GENERAL REMINDERS

Q+A QUESTIONS + ANSWERS – Questions submitted through September 20, 2024

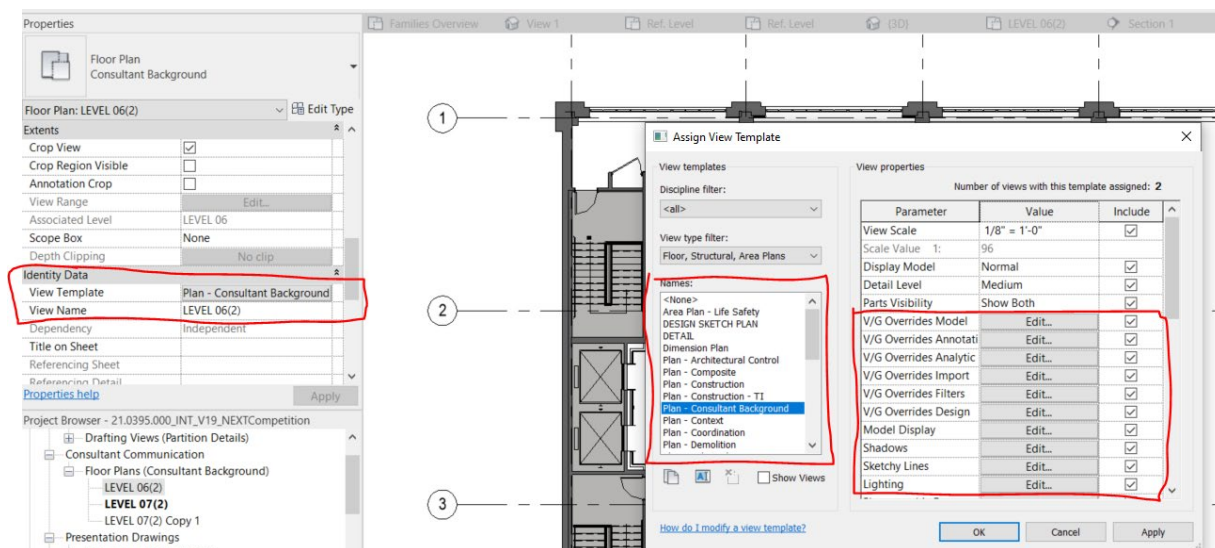
Q: I have a question in regard to working on the REVIT file. When I click on the Consultant Communication: Floor Plans (Consultant Background), no walls or furniture will appear when I place them. That being said, what plan/view/ layout is the best for us to design in or what settings should we modify?

A: I'd suggest checking the parameters of the wall to see if it has any base offsets or base constraints (that's for walls):

For furniture, I would suggest changing/editing/creating the/a View Template that suits your needs.

It can be changed on the Properties tab > Identity Data > View Template, you can edit the templates or create a new one there.

I suggest you keep working on the Floor Plans (Consultant Background) LEVEL 06 and LEVEL 07, or you could create a new view as long as you meet the competition requirements/guidelines.

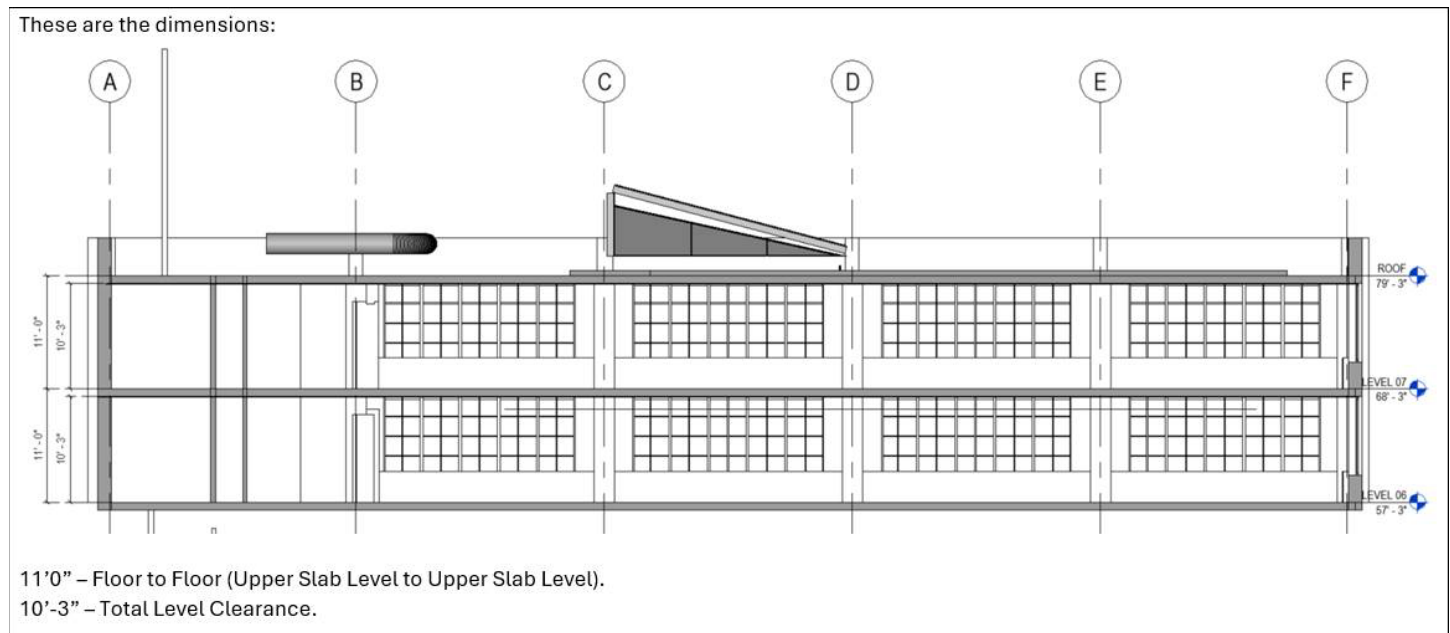
Q: Does the elevator provide access from ground level for all visitors or is card access/swipe used for Next employees only?

A: Elevator access is from ground level lobby.

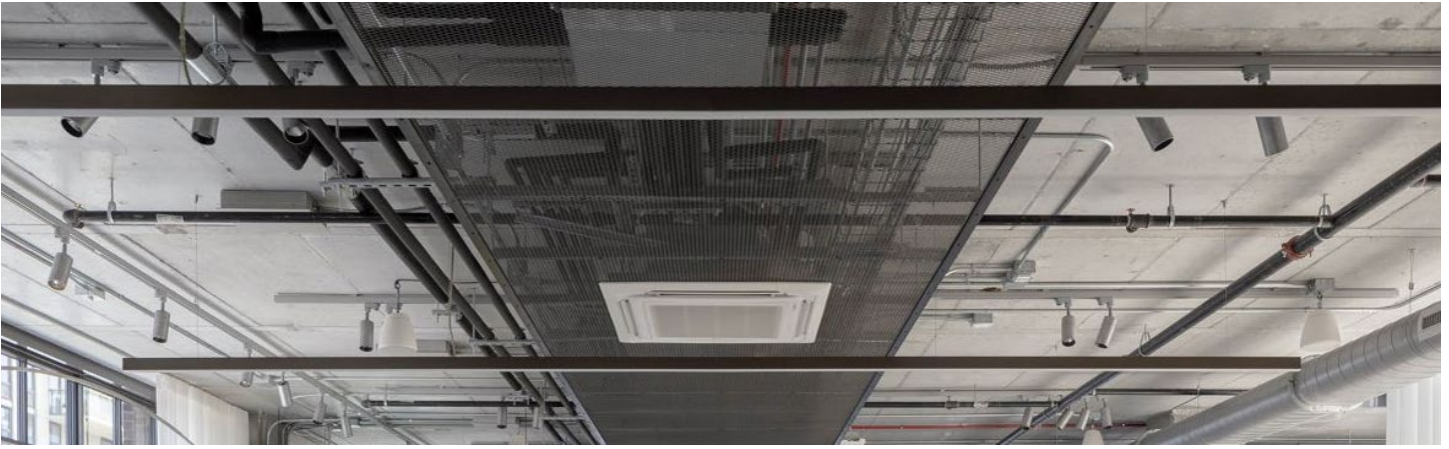
Q: Please provide specifics about the HVAC, such as is the duct work near the ceiling and/or along the exterior walls.

A: I have attached a few photos of the existing HVAC system as it is currently installed:

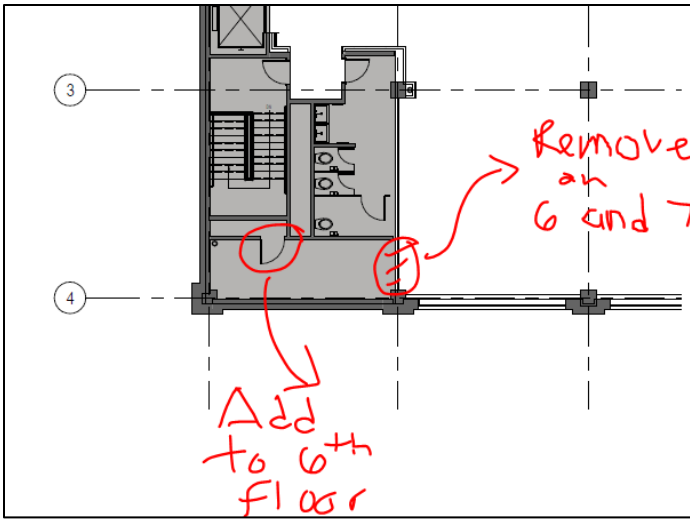
Q: Some of the existing walls do not go to the ceiling in Revit. Is this correct or should all existing walls go to the ceiling?

A: Assume all go to the ceiling.
